## **State Route 60 Automated Truck Facility**

Final Report Report No. CA03-0523 December 2008

Appendix B – Draft Report Review Comments

Figure 1.1 Highway speed trend in LA County – Source: MTA 2002 Long Range Plan

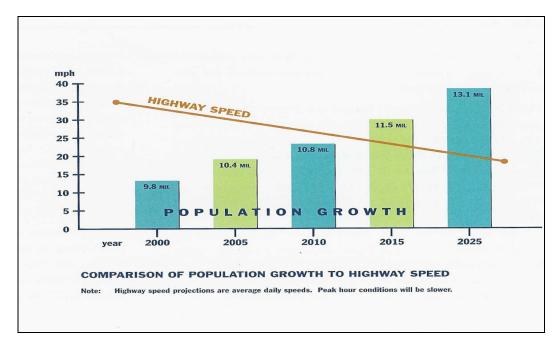
| No | Pg | Section | Reviewer  | Client Comment   | SAI Response   |
|----|----|---------|-----------|--|--|
|    |    |         |           | Page 3 – the graph is somewhat deceptive   | Good comment and well taken. The                                   |
| 3  | 3  | 1       | Steven W. | because the x axis is compressed. Show how   | objective of the graphs is to show                                 |

Figure 2.10 Typical check-out scenario 2 grade separation – automated truck lane below arterial

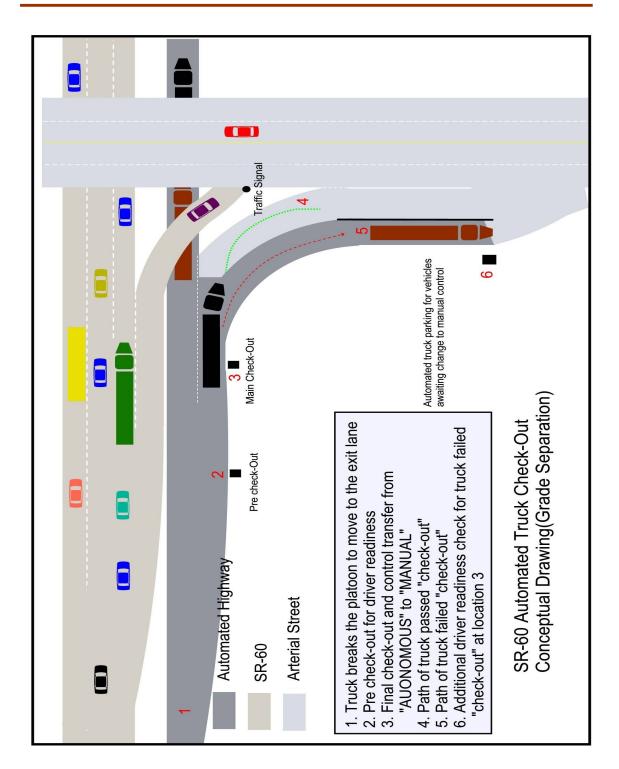
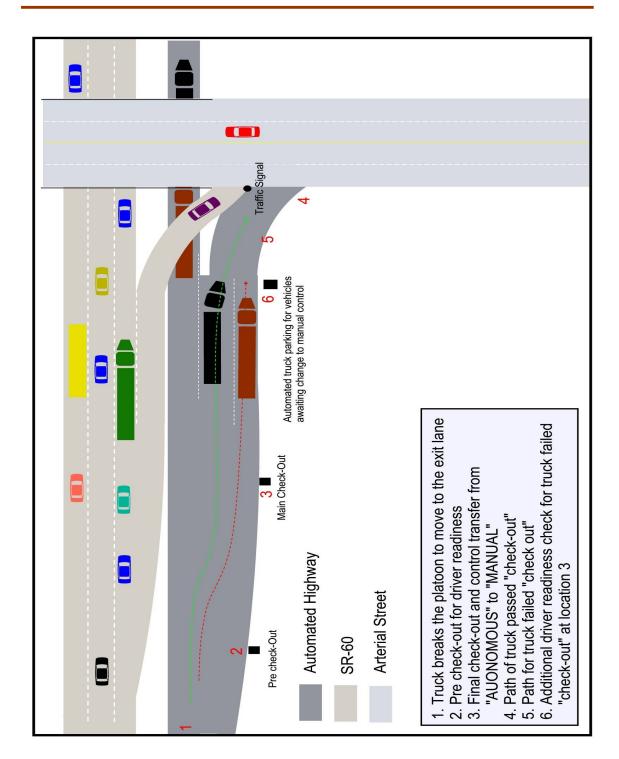
| No | Pg   | Section | Reviewer            | Client Comment  | SAI Response                            |
|----|------|---------|---------------------|---|---|
|    |      |         |                     | Page 23, 24, 25 The traffic signal, is this a ramp  | The figure shows a generic solution.    |

Figure 2.13 Emergency vehicle access options

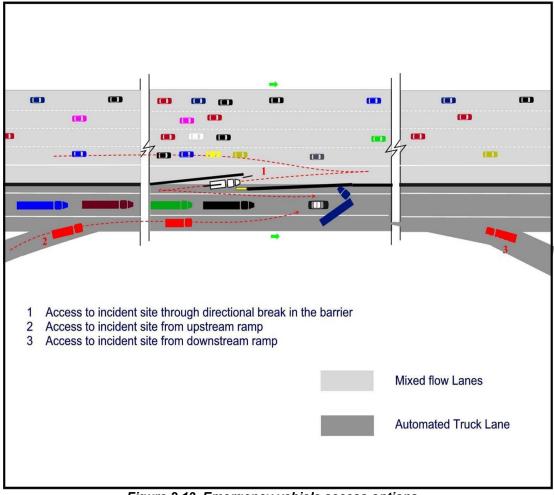
| No | Pg   | Section | Reviewer            | Client Comment  | SAI Response                            |
|----|------|---------|---------------------|---|---|
| 12 | 30   | 2       | Stoven W            | Page 30 Add lost load and lost air to possible  | This comment has been                   |
